AGENDA
PLANNING AND ZONING COMMISSION MEETING
CITY OF CREVE COEUR, MISSOURI
MONDAY, NOVEMBER 4, 2013
7:00 PM

Application #13-019: Site Concept and Site Development Plan Approval of a 25,653 sq. Ft. Retail Grocery Store, The Fresh Market

**APPLICATION TO PLANNING AND ZONING COMMISSION
#13-019 FOR SITE CONCEPT AND SITE DEVELOPMENT PLAN
APPROVAL OF A 25,653 SQ. FT. RETAIL GROCERY STORE, THE
FRESH MARKET**

Site Layout

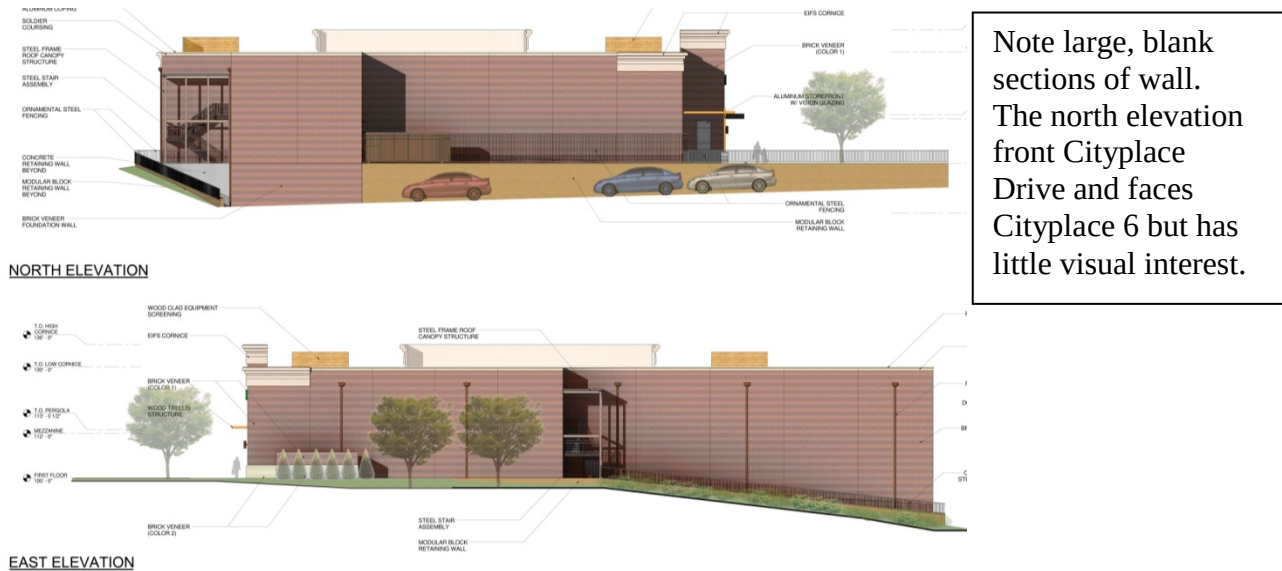
Physical Features and Site Relationships

environment there. If the floor elevation should not be changed, the alternative is to add greater detail to the rear (north) of the building and add interest to the retaining walls located there.

NORTH ELEVATION

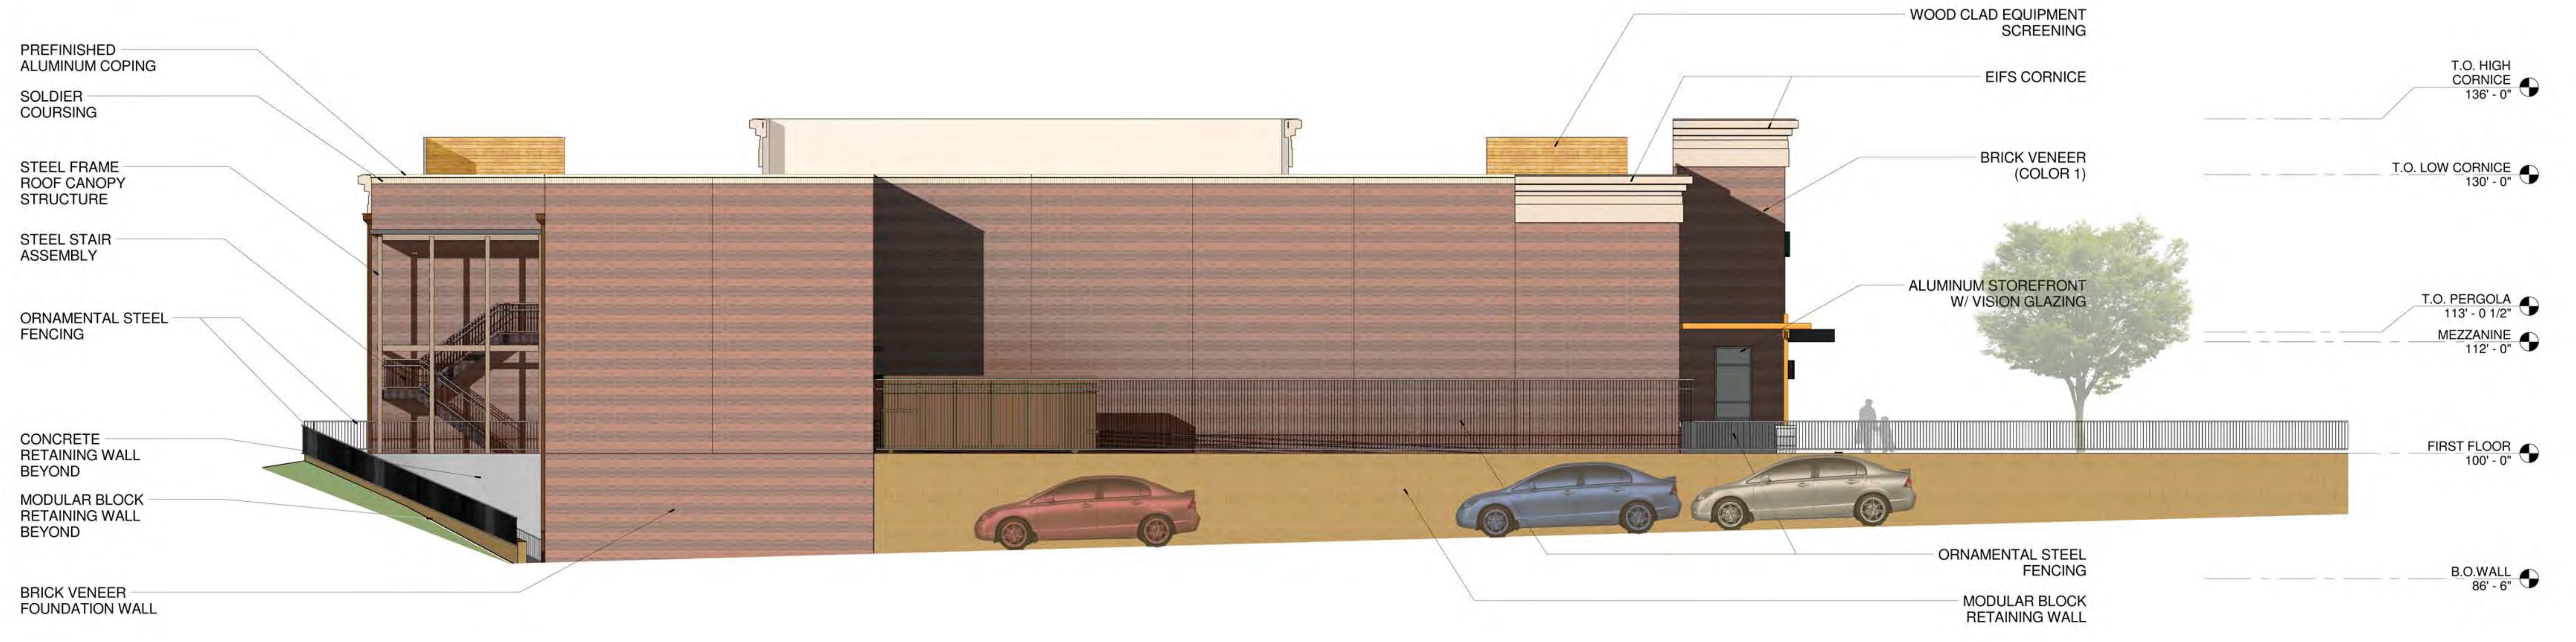
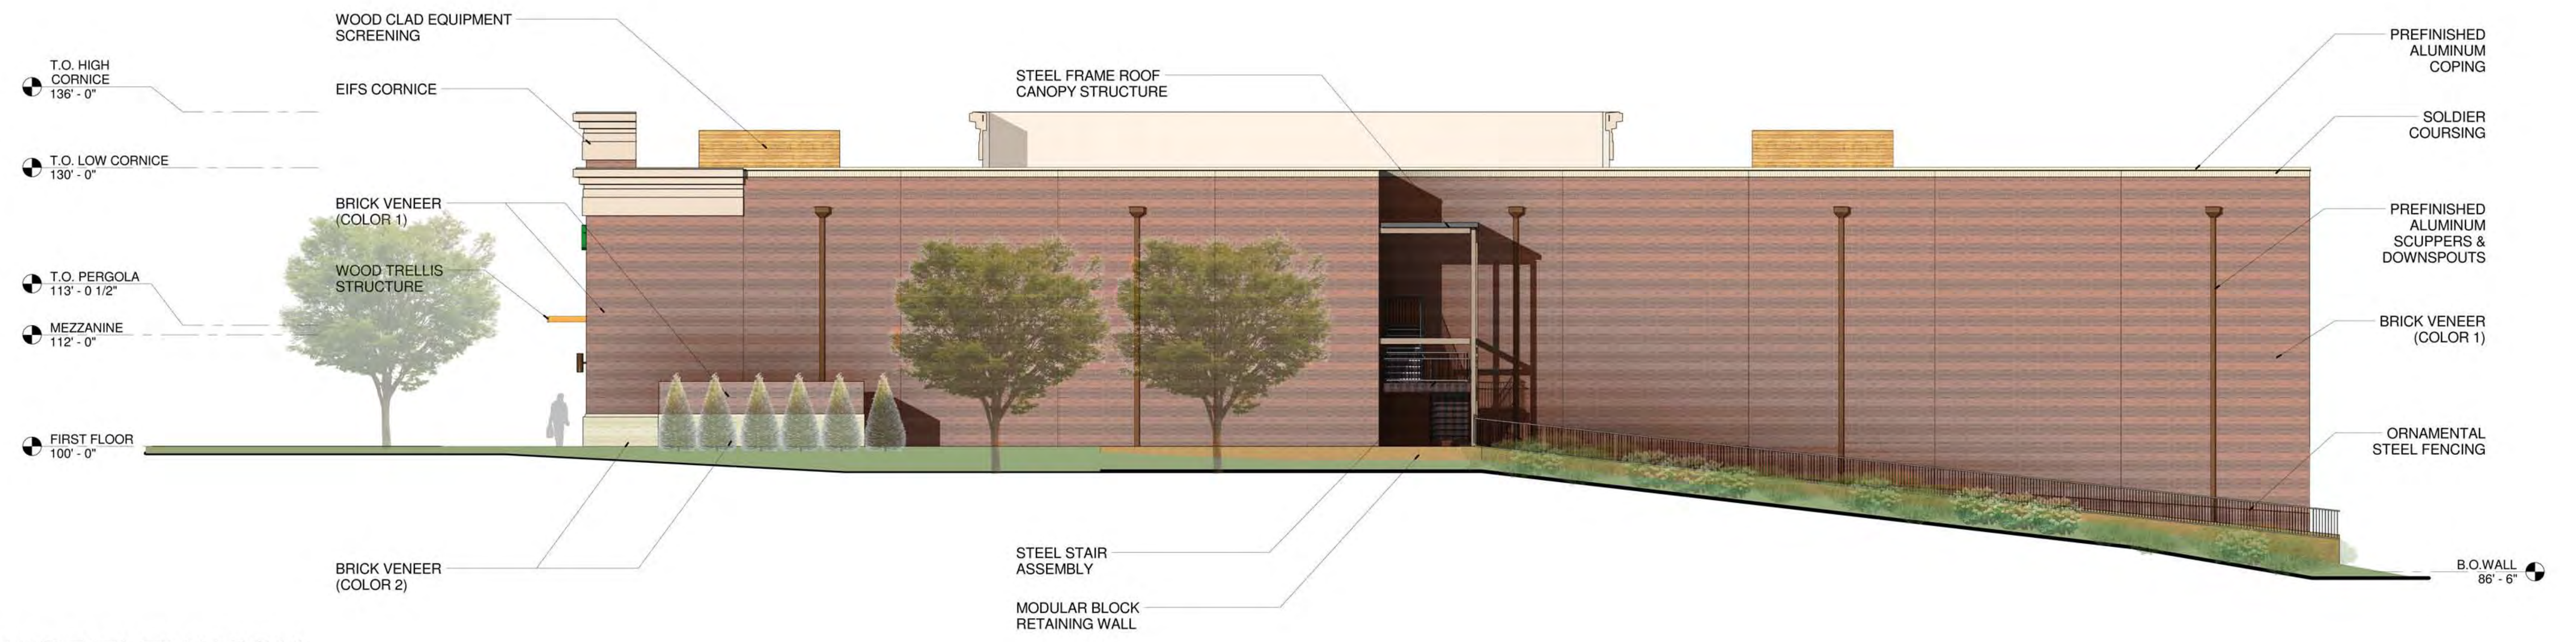
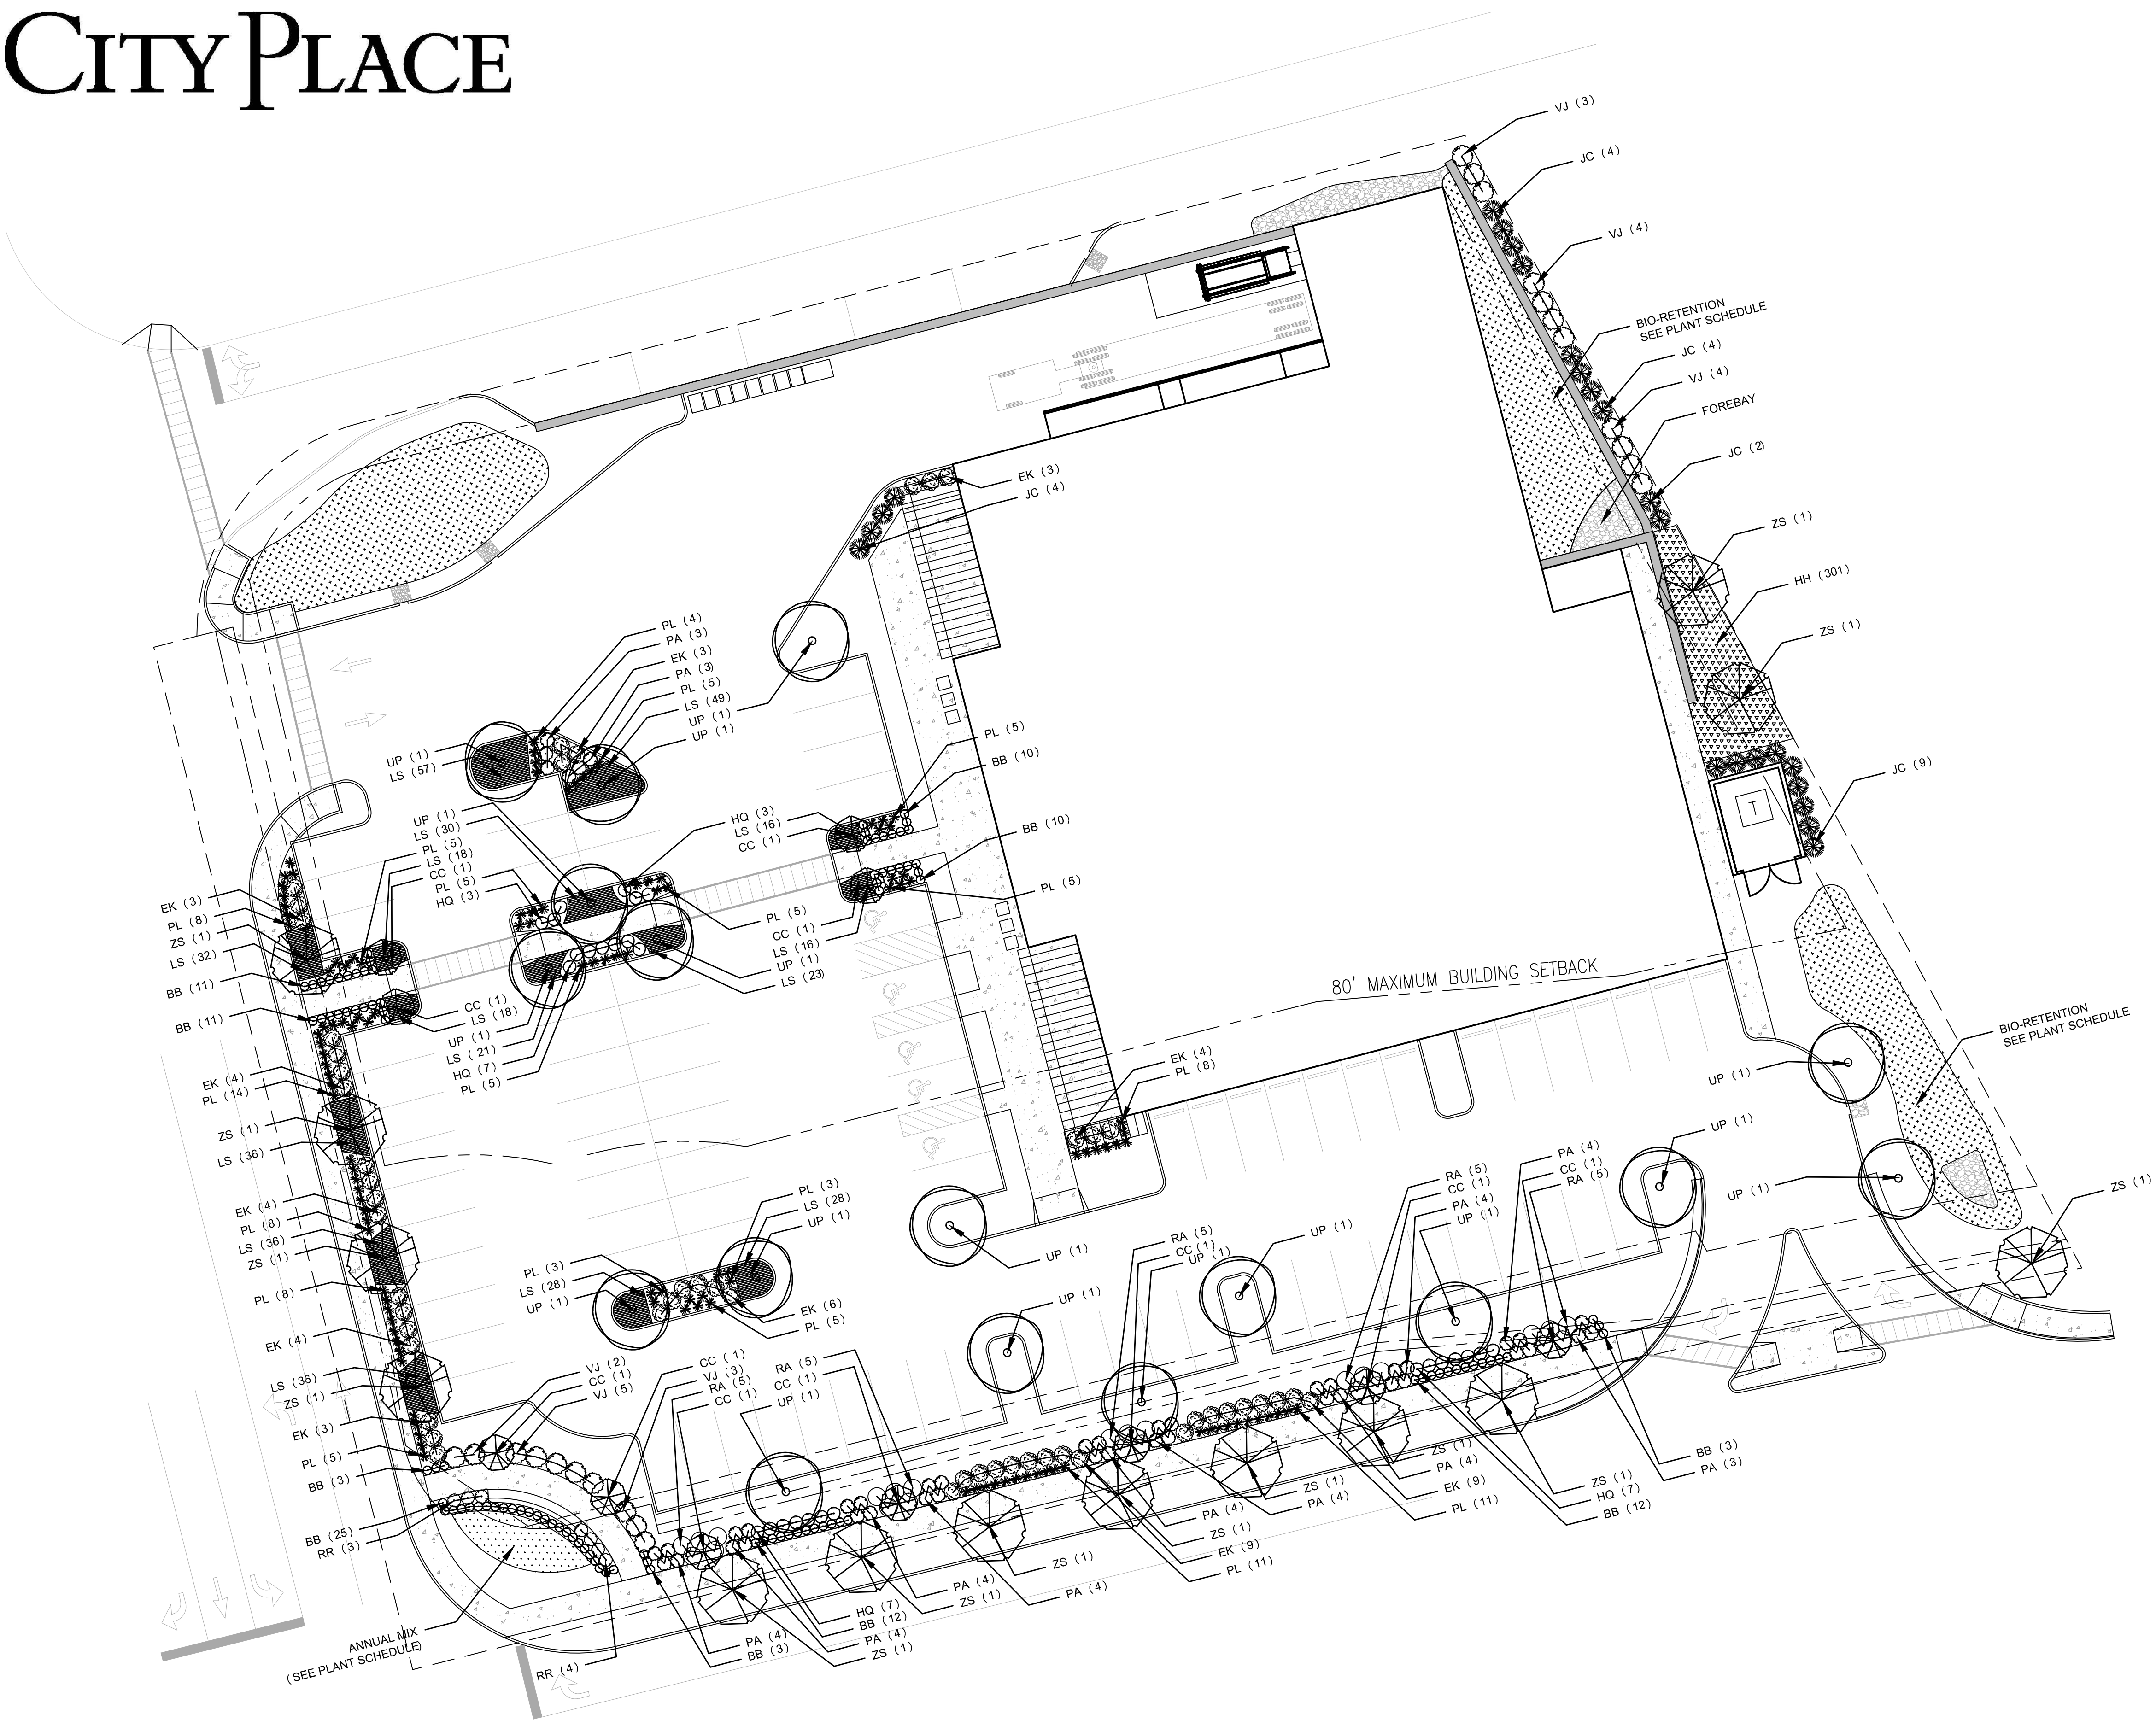
The use of inlaid brick and wood detailing is consistent with the quality materials objectives, with the various caveats discussed above. The design of the front façade element is somewhat “thin” as it does not extend back past the front of the main box (see Figure 3 above). Given the otherwise simple box nature of the structure, staff suggest that the Commission discuss this element further with the applicant. Even a modest extension of the entrance roof back over the main roof would improve the conformance with these guidelines.

- The front façade of the building has been changed and should be evaluated by the Commission for conformance with the Design Guidelines.
- The north side and rear of the building do not conform with the design guidelines as they do not show the same use of materials and design elements as the other two sides.

Figure 1: Detail of Site Plan submitted by Applicant

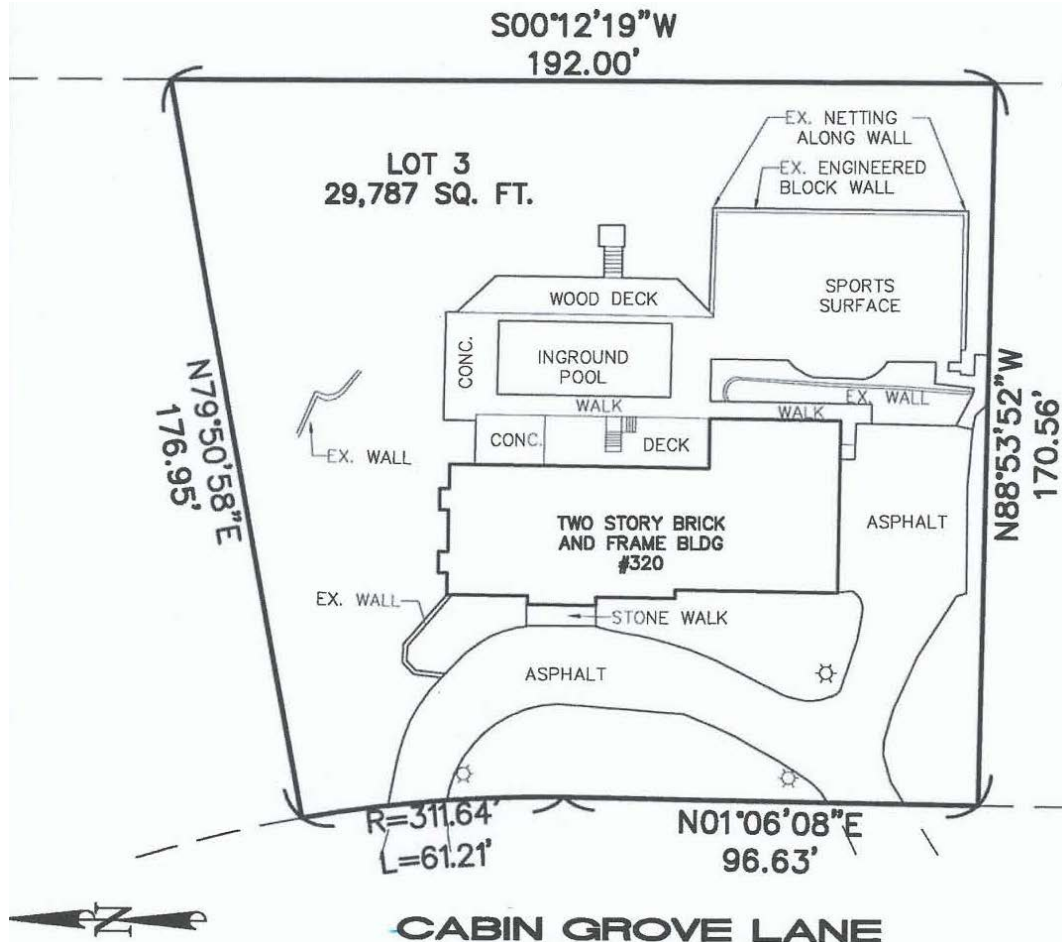
The fence is a black netted material that surrounds the facility on the south, east, and north, suspended by eight aluminum poles. A retaining wall and the garage enclose the west. No lighting for the court is being requested. The applicant contends that the slope of the property and wooded area requires a higher fence to prevent equipment from leaving the property. Below is a copy of the site plan showing the location of the sports court and fence:
